# SERVICE LETTER

No. 582A

Subject: Turbocharger Exhaust System Inspection and Modification -- reference attached Avco Lycoming Service Bulletin No. 339A, dated March 29, 1974.

SUBJECT: Turbocharger Exhaust System Inspection and Modification

Figure 1. Left Side of Engine Showing Area for Inspection

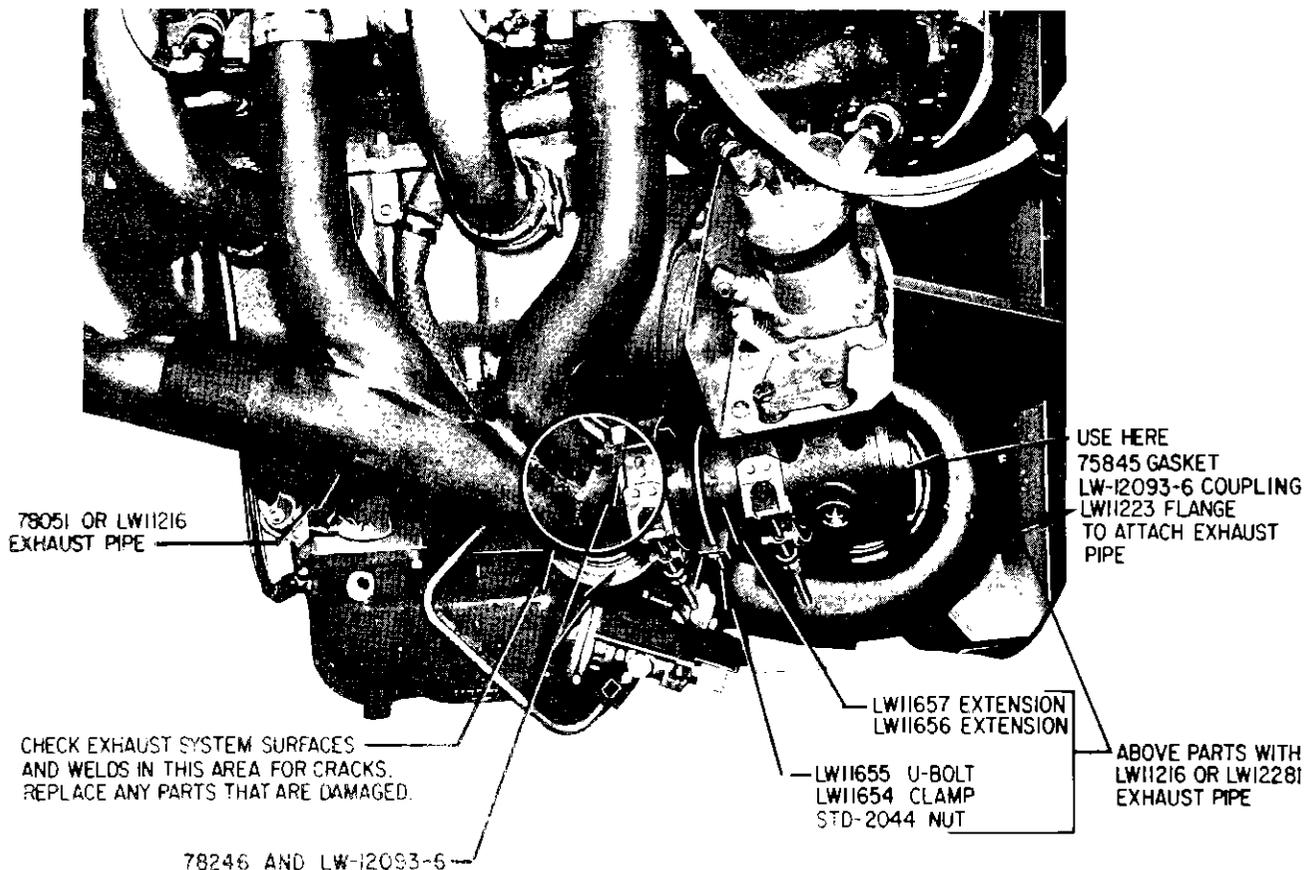
3. With the aid of a flashlight and mirror, visually examine the exhaust system on the left side of the engine; pay particular attention to the surfaces and weldments of the pipe leading to the exhaust bypass valve. Replace any part of the exhaust assembly that shows any evidence of cracks. See figure 1; also see Parts Data list for replacement parts information.

Avco Lycoming P/N 75845, V-band coupling gasket, and V-band coupling, P/N LW-12093-6, are shipped in the following manner: (1) each are attached at the location shown in figure 1 and (1) each are shipped loose to be attached during engine installation.

NOTE: Revision "A" changes figure 1 by revising part numbers, adding location of 78246 and LW-12093-6 gaskets and v-band couplings, and adds shipping note.

Figure 2. Rear View of Turbocharger Showing Details for Bracket Installation

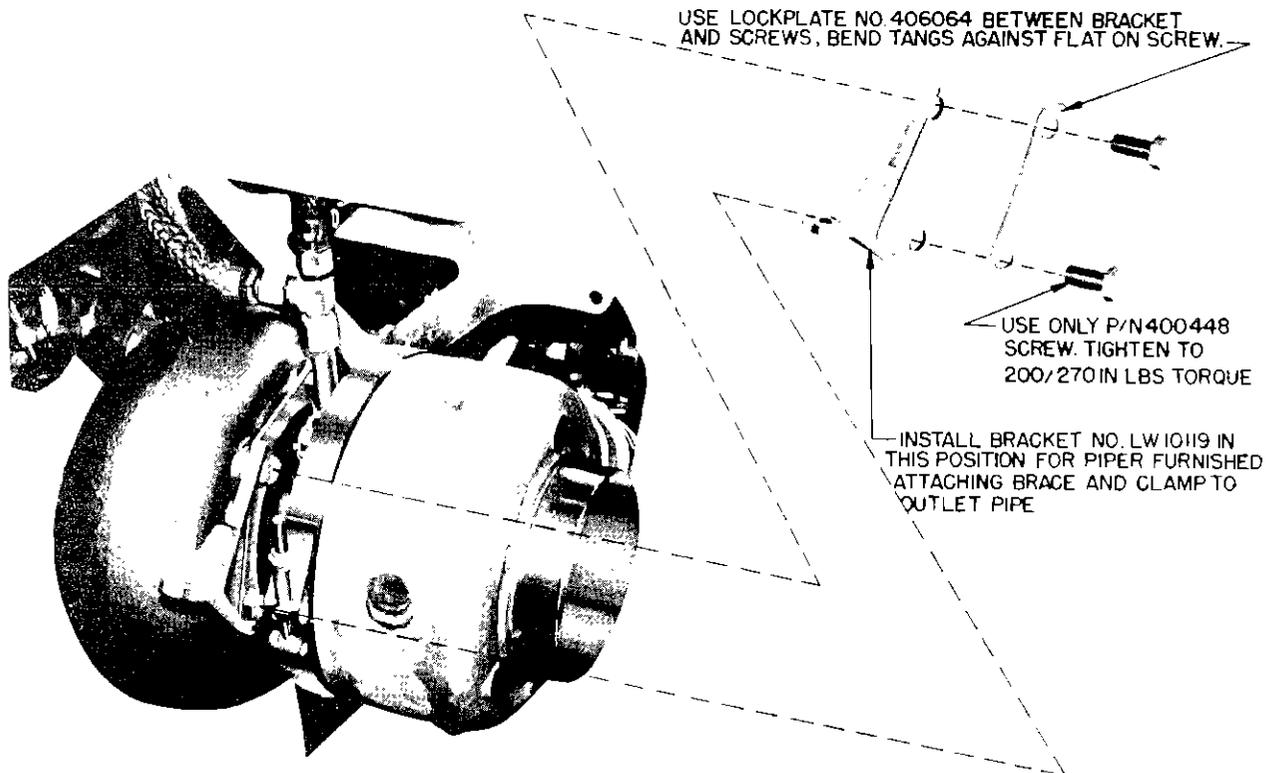
1. Flatten the tabs of the two lockplates located at the turbine housing as shown in figure 2.

2. Saturate the area of the two cap screws indicated in figure 2 with Kano Kroil, Liquid Wrench or equivalent solvent 12 hours prior to removing the screws as described in the following step: this will tend to loosen the screws and permit their removal.

3. Remove the two 3/8-16 screws from the location shown in figure 2 and scrap, and make sure the tabs of the lockplates are reasonably flat so that they will not cause a false torque indication when the new bracket is assembled over old lock tabs.

4. Orient the new bracket (with its flanged side toward the right) and a new lockplate and attach them to the turbine housing using new 3/8-16 screws. Apply Fel Pro C5-A or C100 to the threads of the screws before assembly. Torque each screw to 200/270 inch pounds and bend the tabs of the new lockplate against the flat on the screws. See figure 2.

Figure 3. Assembly Procedure for Tailpipe Bracket and Clamp Components

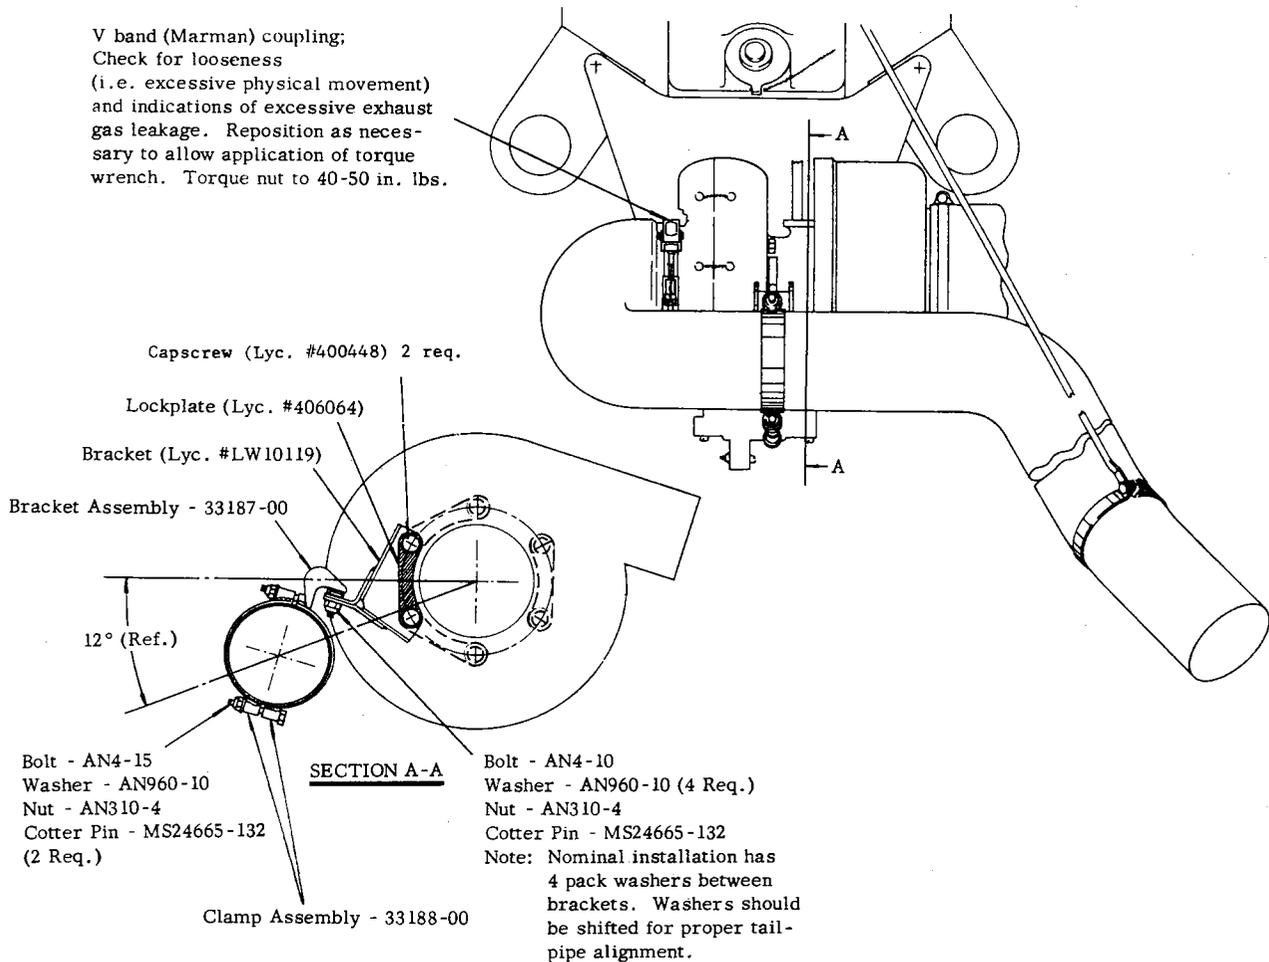
1. Remove inboard and outboard engine cowl panel assemblies and grasp the tailpipe assembly to determine if movement is discernible between the tailpipe and the turbine outlet at the v-band coupling (Maraman clamp). See figure 3. If movement is evident remove the bottom cowl assembly and remove the v-band coupling; reinstall it and tighten the coupling nut to 40-50 in. lbs. torque.
2. Again check the tailpipe for movement. If still loose, install a new v-band coupling (Piper part no. 555376) and safe-tie the nut after tightening to 40-50 inch lbs. torque.

5. See figure 3 for installation of tailpipe bracket and clamp assembly.
6. Indicate compliance with this bulletin in aircraft records.
